Site: 1385 Hillside Circle, Burlingame, CA

As requested on December 4<sup>th</sup>, 2023, Kielty Arborist Services visited the above site to provide a Tree Inventory Report/Tree Protection Plan for the proposed construction. 3 new homes are proposed for this site, and your concern as to the future health and safety of the tree has prompted this visit. Preliminary landscape plans L1 through L7 dated January 2024, lot 1 site plans A.1 through A.6 dated 10/26/22, lot 2 site plans A.1 through A.6 dated 10/26/21, and lot 3 plans A.1 through A.8 dated 10/26/21 were also reviewed for writing this report. This Tree Inventory Report is not a Tree Risk Assessment. As such, no trees were assessed for risk in accordance with industry standards, nor are there any tree risk ratings or risk mitigation recommendations provided within this preservation plan.

**Showing portion of driveway recommended to be retained until the landscape phase of the project.**

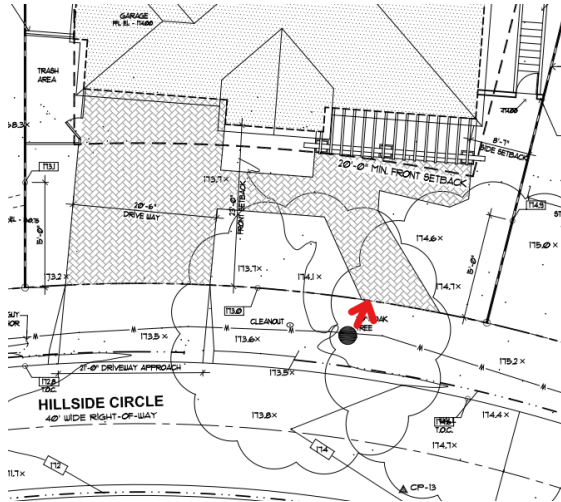
Oak tree #1 is to be retained. The tree is adjacent to an existing driveway. It is recommended to temporarily retain the existing driveway near this tree when underneath the dripline of the tree during the building phase of the project. Temporarily retaining the driveway will act as a tree protection measure and will help to increase staging and access to the site, as removing the driveway at the beginning of the project would make for a larger tree protection zone needed with the fencing being located at the tree's drip line. The existing grade within the tree's dripline is recommended to be retained as is where possible. No grading or excavation is recommended to take place within 10' from this tree (6x diameter) except for the removal of the driveway. At the end of the project, when it is time to demolish the existing driveway near this tree, the Project Arborist is

recommended to be on-site to document and witness the removal of the driveway. A jackhammer is recommended to be used when working within the tree's dripline to break the concrete material into hand manageable-sized pieces. Once broken down the driveway material is recommended to be removed by hand. Exposed roots during the process are recommended to be wrapped in layers of wetted-down burlap to avoid root desiccation. The existing driveway area is recommended to be filled back in once the driveway has been removed so that no roots are exposed to the elements. When backfilling the soil in this area, the area is also to be irrigated. The proposed driveway is further from the tree than the existing driveway and outside of the 10' range and is not expected to have impacts on the tree. The tree is recommended to be deep water fertilized with Nutriroot once the work near the tree has taken place as a mitigation measure for any minor impacts that may take place.

**Showing the walkway at 4' from the tree**

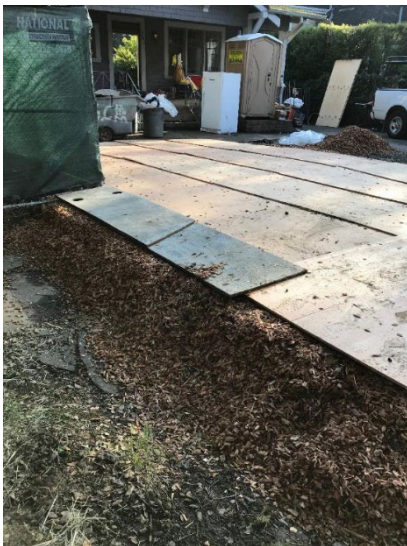
A new pathway is proposed at 4' from oak tree #10. This is too close to the tree and impacts would be expected. It is recommended to maintain a minimal clearance of 10' from the tree to the pathway to keep impacts on the tree low. With this plan change implemented, impacts are expected to be minor and will be mitigated by the recommended deep water fertilizing with Nutriroot.
